MINOLTA XG UPDATE

Note: This list of updates applies to models earlier than the XG-M (XG-7, XG-1, XG-9). The XG-M already has the revisions noted.

FIGURE 1

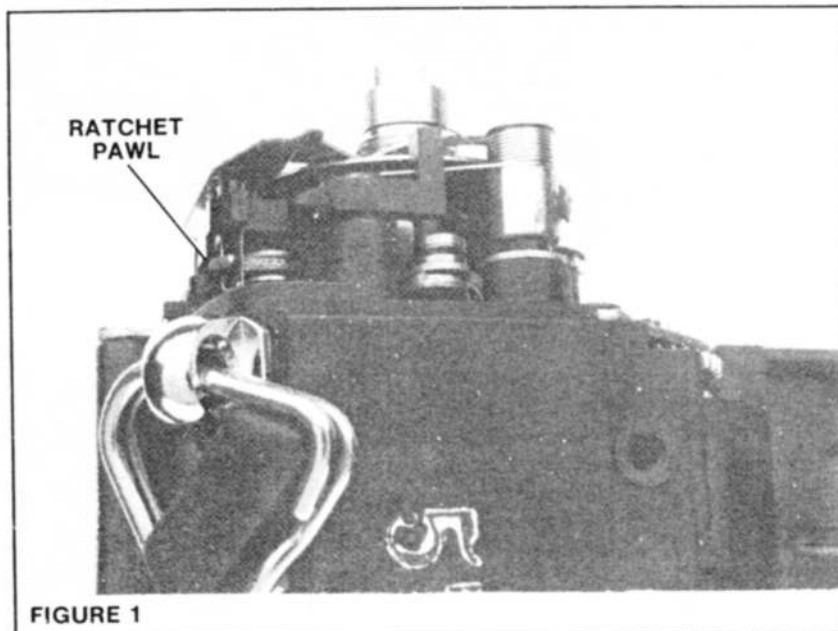
1. The ratchet pawl that engages the wind ratchet now mounts to the base plate rather than to the underside of the counter assembly, Fig. 1. If you don't get the ratchet during the wind stroke, check to see if the post for the pawl has come loose from the base plate. The normal symptom is that the camera comes in jammed—the mirror is up, but the shutter is already in the released position. You can restake the post after removing the base plate.

FIGURE 2

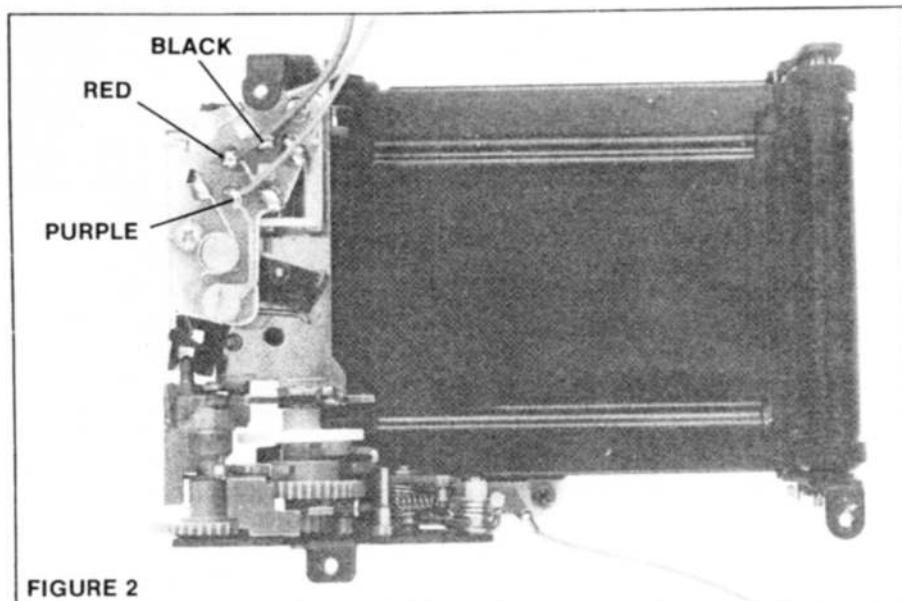
2. The shutter block has been revised, Fig. 2. Shutter blocks will interchange, but note the wiring to the shutter board.
3. The release magnet Mg2 has been revised. The new style doesn't have the post on the armature, Fig. 3. If you replace an old-style magnet with a new-style magnet, also replace the release-coupling arm (the arm that the release magnet engages to release the mirror); the new style has an upraised tab that connects to the new-style magnet, Fig. 3. New-style magnet — 2019-0850-11. New-style release-coupling arm — 2006-0527-02.

FIGURE 3

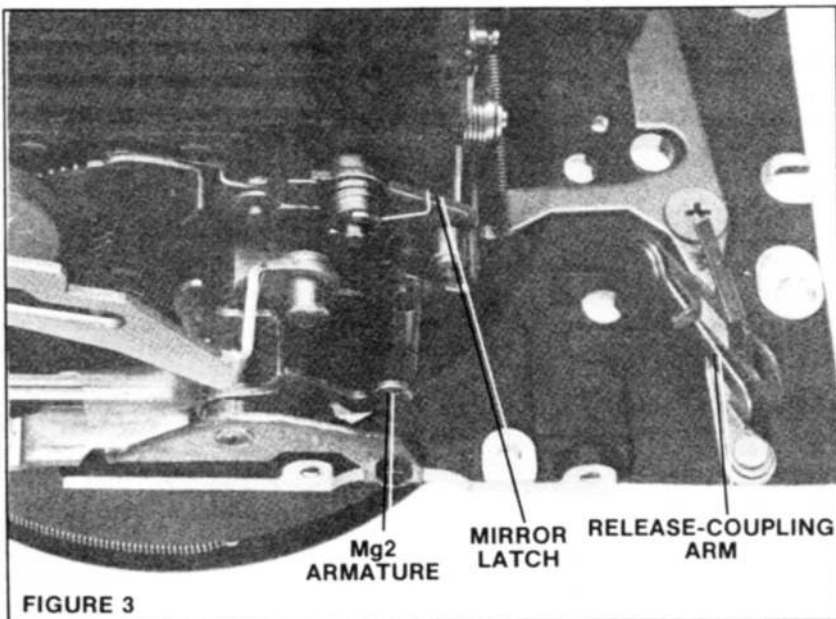
4. The mirror latch, Fig. 3, has a third revision. The old style (2006-0522-01) has a small post (2mm). The revised type has a larger post (2.5mm) because of the new-style brake system at the bottom of the shutter, Fig. 4. The latest revision (2006-0522-03) has a 3mm roller. You can use the latch with the roller in cameras that have the new-style brake system, Fig. 4. The revision corrects for mirror sticking

FIGURE 4

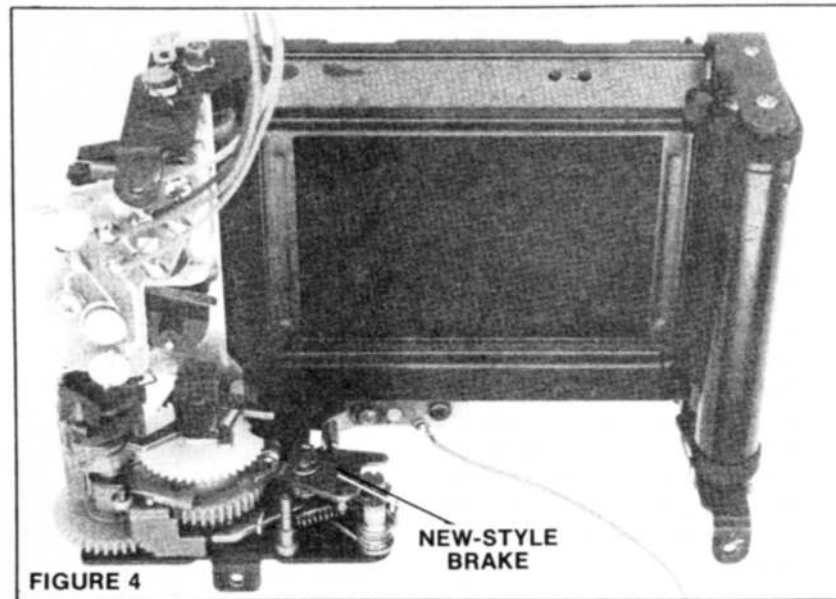
- (mirror hanging in aperture during exposure, especially evident at the slow speeds).
5. The take-up spool and shaft have been revised. The new-style shaft is plastic, and the take-up
